# Addendum #1

Attn: Estimator	Date: February 21, 2024
From: Lisa Donahue, Project Administrator	Pages: 92 (including cover page)
Re: Bay City Public Schools	Project: 2024 SF BP 11 – Eastern HS at Handy MS
CC:	Proj. #: A23904

PROJECT TITLE  
 RENOVATION FOR BCPS:  
**BAY CITY EASTERN HIGH SCHOOL AT HANDY M.S.**

PROJECT NUMBER <b>2018040.16</b>	SHEET NUMBER <b>A2.12</b>
PROJECT DATE FEBRUARY 1, 2024	
CHECKED BY J.A.R.

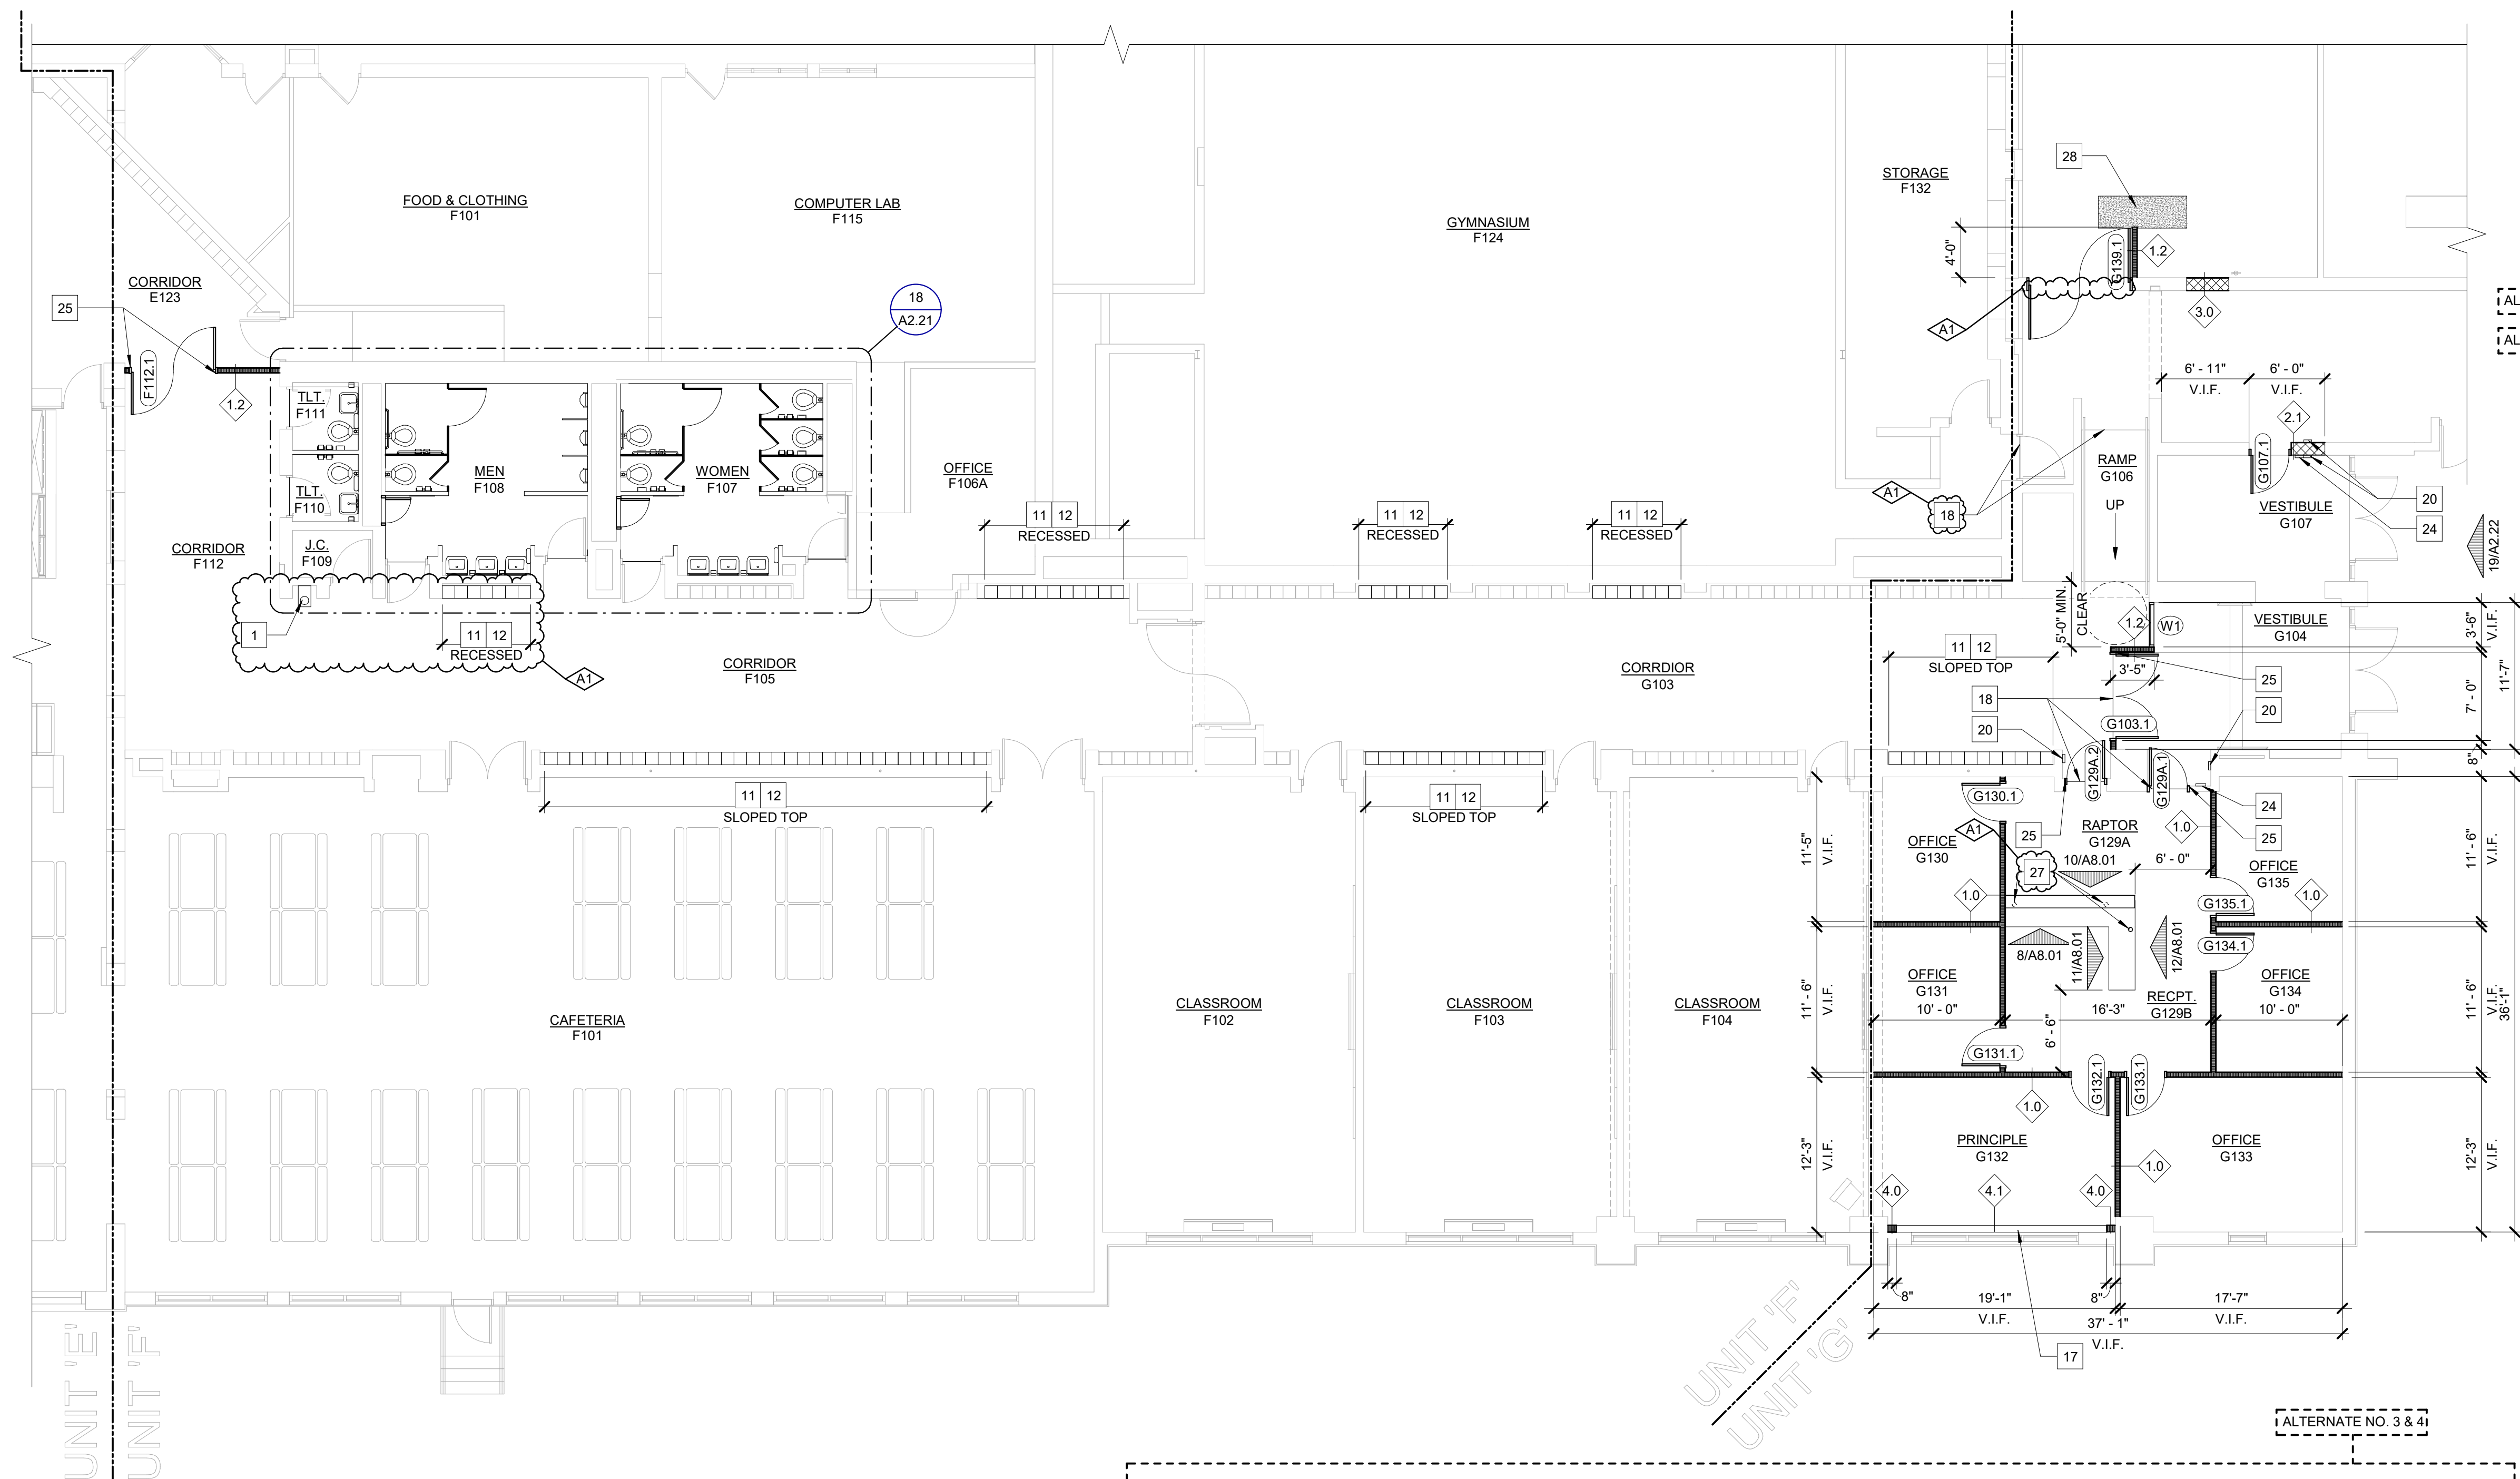
- Item A6: Reference Sheet A2.11 & A2.12 (Re-Issued)
- A. Revised demo keynote #22 to remove lockers per Alternate No. 2 in lieu of to be relocated.
  - B. Revised demo keynote #27 to grind off adhesive.

- C. Revised demo keynote #30 to remove mud bed down to concrete slab or substrate.
  - D. Added demo keynote #36 to remove existing structural glazed tile shelves in the toilet rooms.

- E. Added demo keynote #37 to remove existing VCT flooring and base in existing classrooms (G101, G102, G109), Science

- F. Added demo keynote #38 to sawcut and remove existing terrazzo in Corridor G103 & G108.
- G. Added demo keynote #39 to strip and prep existing terrazzo for new VCT.
